TOSHIBA Microcontrollers
TX03 Series

TMPM330FDFG TMPM330FYFG TMPM330FWFG

Restrictions on Consumer Electronics Control (CEC)

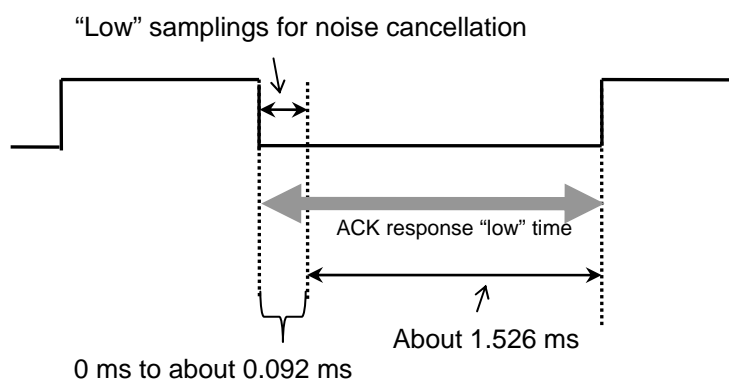
Restrictions are applied when the “low” samplings for noise cancellation, CECRCR1<CECLNC>, is used as the CEC function.

1. Set the same values to both “low” samplings for noise cancellation CECRCR1<CECLNC> and the rising timing of data bit CECTCR<CECDTRS>.
2. Set the values of “low” samplings for noise cancellation CECRCR1<CECLNC> between “000” and “011”.

2. "Low" output timing when a minimum cycle error occur

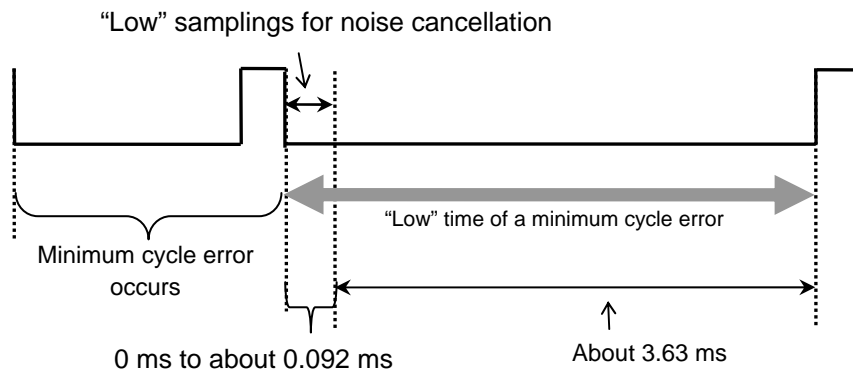
"Low" output timing when a minimum cycle error occurs is as shown below.

Minimum cycle error "Low" time = ("Low" samplings for noise cancellation) + (Base time: 3.63ms)

When a minimum cycle error occurs, "low" signal is output (about 3.63ms) after the elapse of "Low" samplings for noise cancellation.

□ Corrections on the page of ACK response

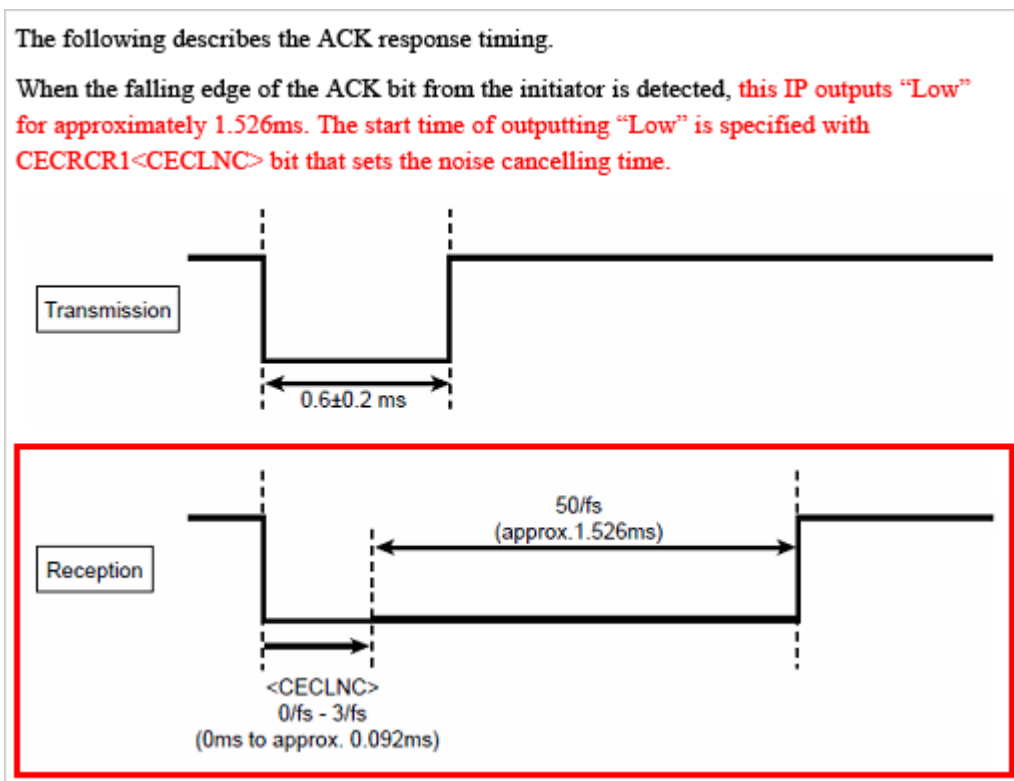
Corrections on the description and the figures of "low" output timing when a ACK response is sent.
